802.3dj D1.0 Comment Resolution Logic Track

Gary Nicholl (Cisco), 802.3dj Chair, Architecture and Logic Track

Clause 177, Inner FEC Sync Comment # 505

Figure 177–8—Inner FEC pad detection state diagram

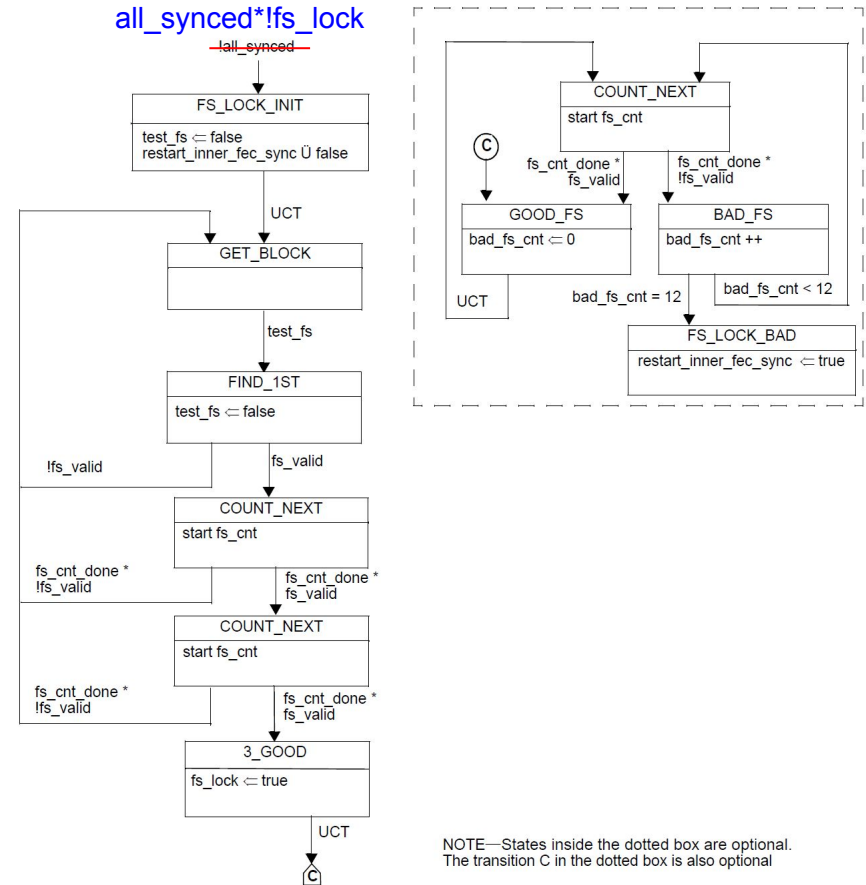
Cl 177	SC 177.6	P 262	L 5	# 505
Ren, Hao		Huawei		
<i>Comment Type</i>	TR	<i>Comment Status</i>	D	<i>Inner FEC Sync</i>
In Figure 177—8, the input variable of state FS_LOCK_INIT is not correct. It would cause a FS lock error.				
<i>Suggested Remedy</i>				
FS_LOCK_INIT state should be entered after all the 8 flows obtain their inner FEC codeword boundaries and inner FEC flow 0 is identified, when fs_lock is false.				
Propose change: Change the input variable from '!all_synced' to 'all_synced * !fs_lock'.				
Change the definition of all_synced from 'A Boolean variable that is set to true when sync_flow<x> is true for all eight flows and is set to false when sync_flow<x> is false for any x.' to 'A Boolean variable that is set to true when inner FEC flow 0 is identified and is set to false when sync_flow<x> is false for any x.' (in page 258 line 48-50)				
<i>Proposed Response</i>		<i>Response Status</i>	W

PROPOSED ACCEPT IN PRINCIPLE.				
Change the condition for FS_LOCK_INIT state from "!all_synced" to "all_synced*!fs_lock"				
Change the definition of variable "all_synced" from: "A Boolean variable that is set to true when sync_flow<x> is true for all eight flows and is set to false when sync_flow<x> is false for any x." to: " A Boolean variable that is set to true when sync_flow<x> is true for all eight flows AND inner FEC flow 0 is identified, and is set to false when sync_flow<x> is false for any x."

Change the definition of variable “all_synced” in 177.6.2.1 as follows:

all_synced

A Boolean variable that is set to true when sync_flow<x> is true for all eight flows AND inner FEC flow 0 is identified, and is set to false when sync_flow<x> is false for any x.

Change Figure 177-8 as follows:
